Lower Thames Crossing
9.104 **Final Agreed** Statement
of Common Ground between
(1) National Highways and (2)
The Master, Fellows and
Scholars of the College of
Saint John the Evangelist in
the University of Cambridge
(Tracked changes version)

Planning Inspectorate Scheme Ref: TR010032
Examination Document Ref: TR010032/EXAM/9.104

9.104 Final Agreed Statement of Common Ground between (1) National Highways and (2) The Master, Fellows and Scholars of the College of Saint John the Evangelist in the University of Cambridge (Tracked changes version)

Appendix B SJC Alternative Design

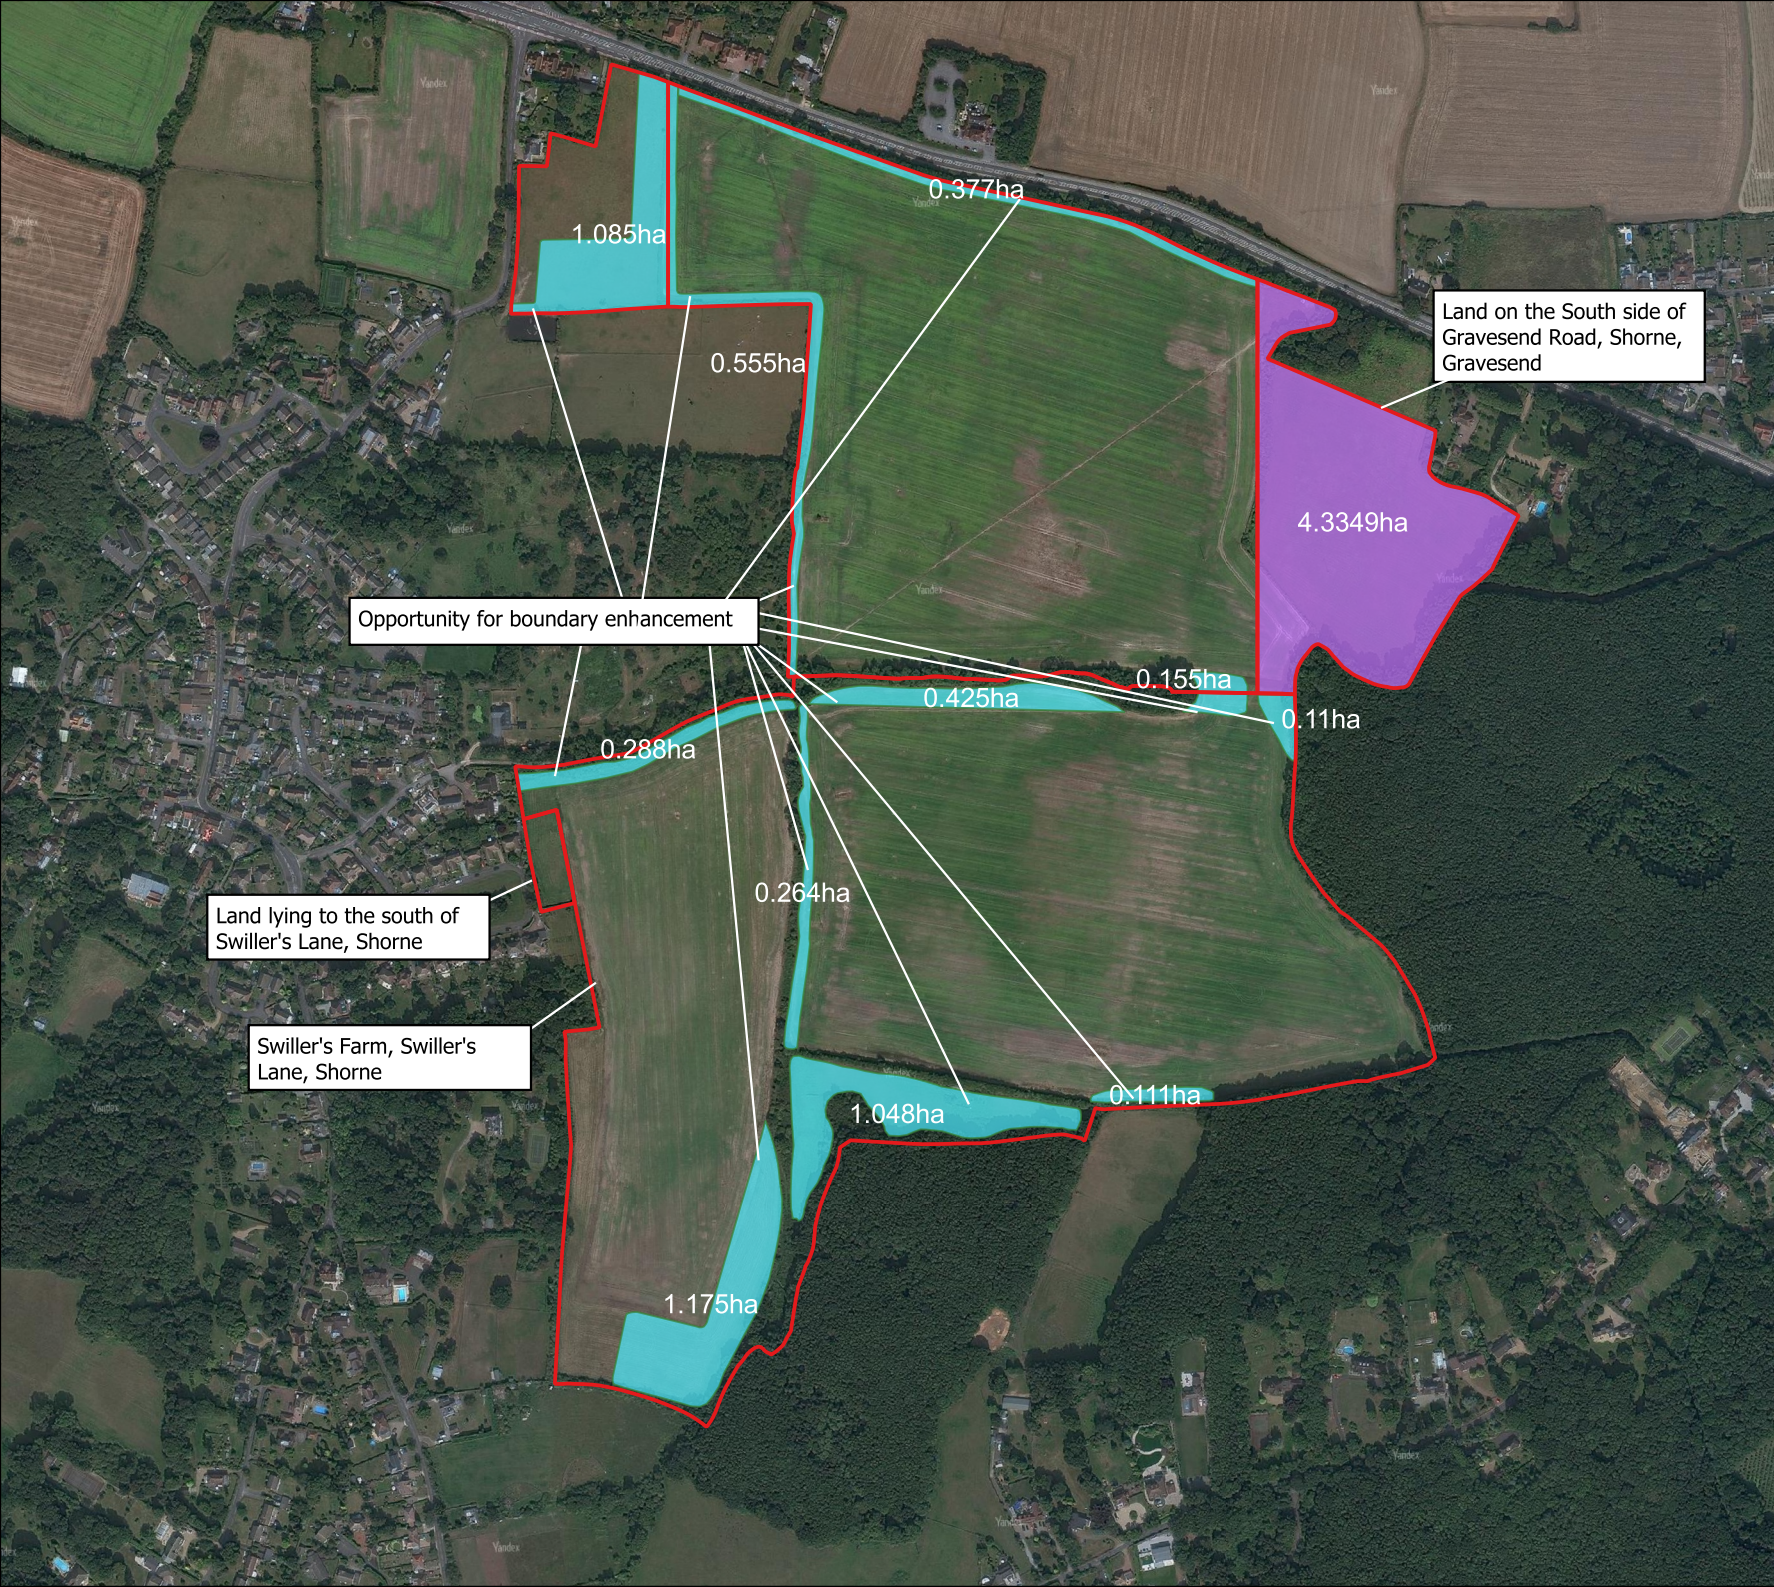
Topic	Item No.	SJC Comment	The Applicant's Response	Application Document Reference	Status
		<p>techniques. This will improve the soil structure and retain it for future generations, contributing to food security. Please refer to the plan appended in Appendix B.</p> <p>SJC notes there is a desire to plant 70% of the land with trees, and would suggest that this should not be done on prime agricultural land if there is a reasonable alternative.</p> <p><u>SJC's alternative proposal was a draft for discussion and SJC remained open to dialogue to agree what corridor widths were necessary to achieve connectivity, having based these on LTC's own design for wildlife corridors. SJC considers LTC's position on connectivity to be unsupported by evidence. SJC does not consider that the site selection methodology set out in the PAQAP is sufficiently clear to justify the acquisition of its land against the alternatives.</u></p>
